**Re: Park 6 at Ventana Ranch, NE Corner of Ventana Rd and Universe Blvd,
Grading and Drainage Plan
Engineer's Stamp dated 10-07-04 (B10-D10)**

Re: Park 6 at Ventana Ranch – Grading and Drainage Re-submittal of approved Park 6 Grading and Drainage Plan
Engineer's Stamp dated 10-07-04, COA Hydrology Department Reference Number (B10-D10)

PROPOSED
CONDITIONS
BASIN MAP

PARK 6 AT VENTANA RANCH

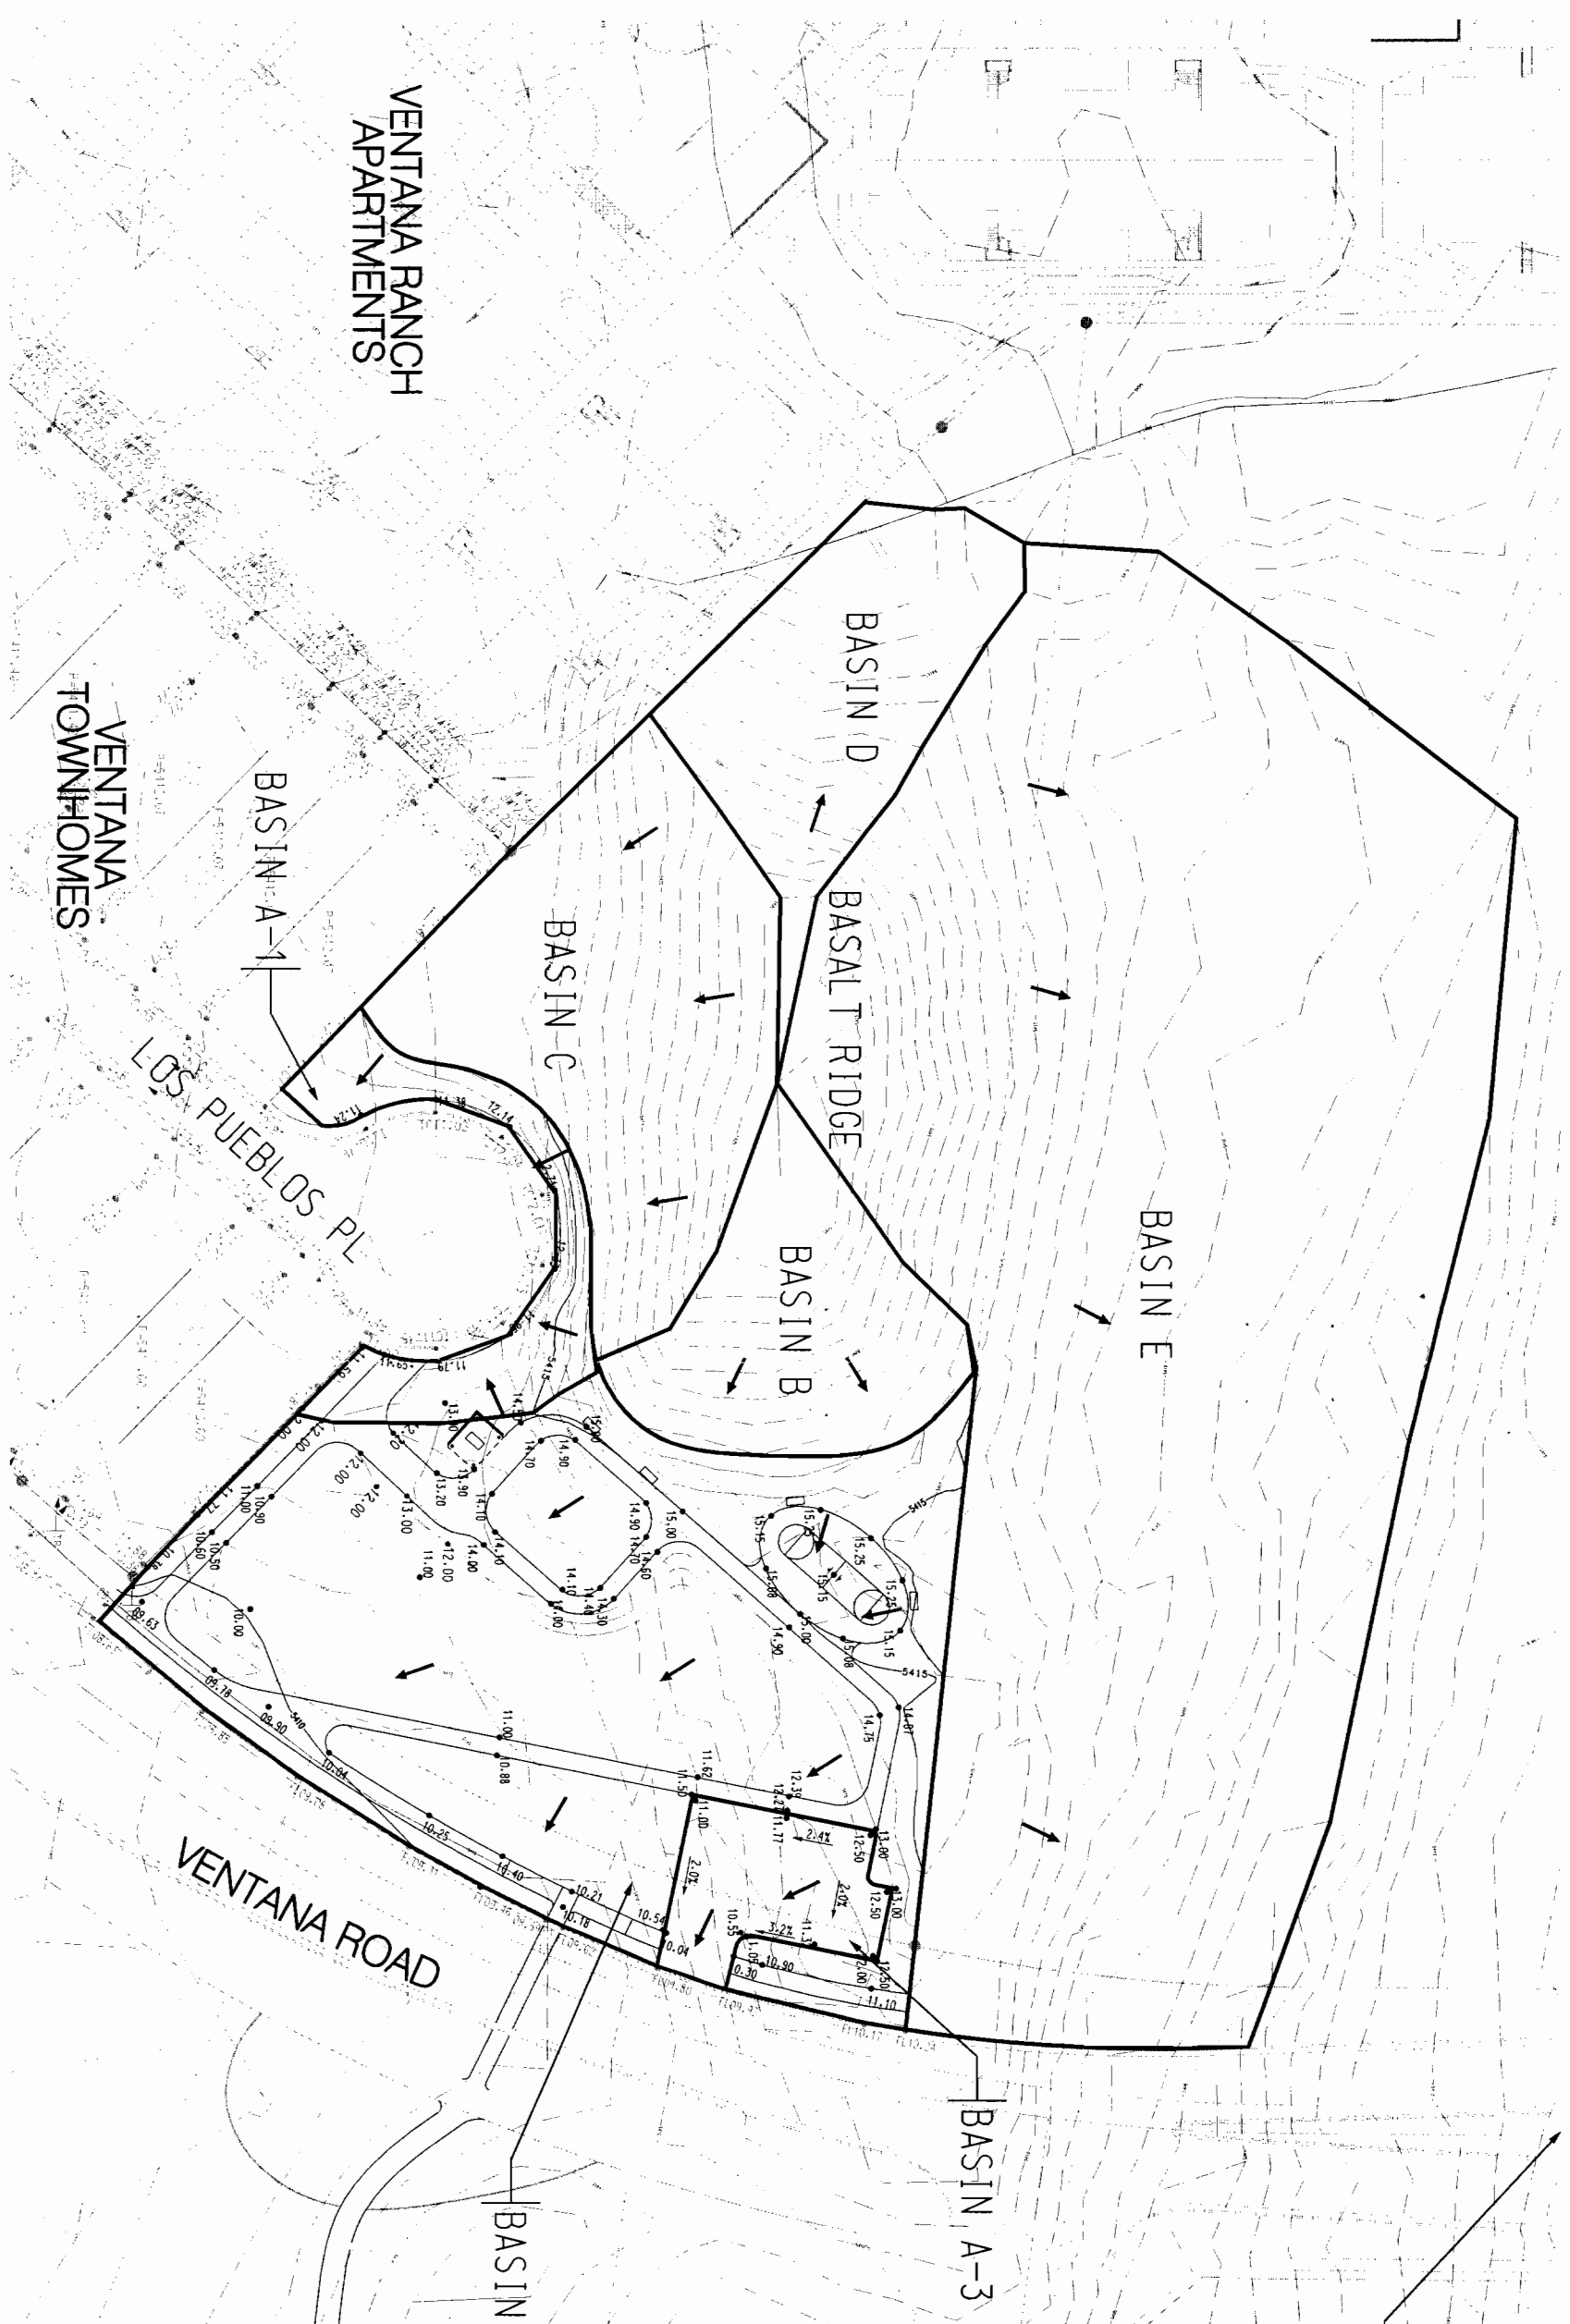
The purpose of this letter is to inform you of changes to the previously approved Grading Plan for Park 6 at Ventana Ranch and request your approval for the Grading Plan induced by these changes. Enclosed are a Proposed Conditions Basin Map which identifies both site boundary and flow basins affecting the proposed site, a table defining hydrological volumetric and discharge data generated by the site and adjacent offsite basins, the necessary SO-19 language in order to work in public right of way for the proposed sidewalk culvert and a copy of the letter which approved the previous grading plan for Park 6 at Ventana Ranch.

During grading of the park, areas of basalt were located at grade for the proposed location of the parking lot. To reduce the amount of basalt to be removed, the parking lot was relocated further south, yet keeping the same location of the parking lot entrance (see Park 6 Grading Plan). Due to the design change, the flow entering the parking lot will be directed to the south east corner and exit through a proposed sidewalk culvert to existing Ventana Road. The overall drainage scheme of the park has remained unchanged.
